PROJECT NAME — EAST MONTPELIER
BRIDGE — 68
PROJECT — BRF 037-1 (7)
—
P.O. NO. — B3137
DESIGNER — STANTEC
CUSTOMER — CCS CONSTRUCTORS

DESCRIPTION: VERSIFLEX ELASTOMERIC BEARING
WASHINGTON COUNTY, VT

SCALE:	DRAWN BY:	CHECKED BY:	DATE:	
N.T.S.	SP	KTG	9/17	–
PROJECT NUMBER	PRODUCT CODE	RELEASE	SHEET	
53418	1104	–	01

PLAN VIEW

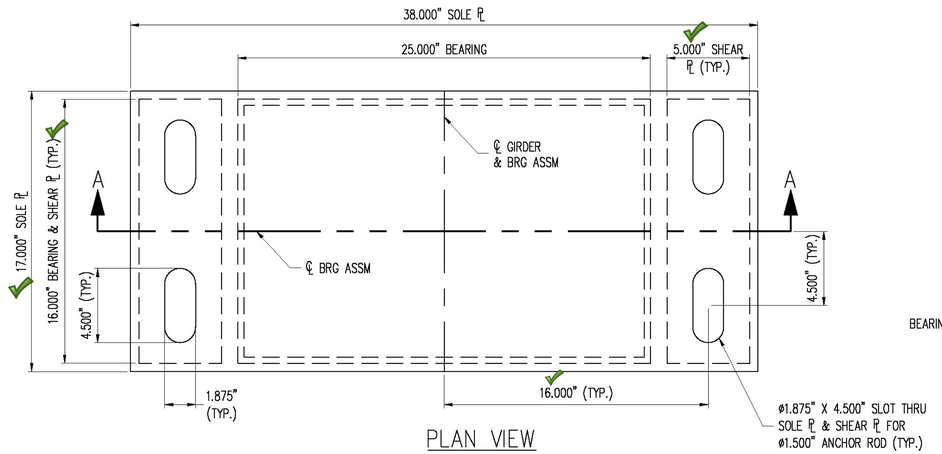
160 +/-15% is OK
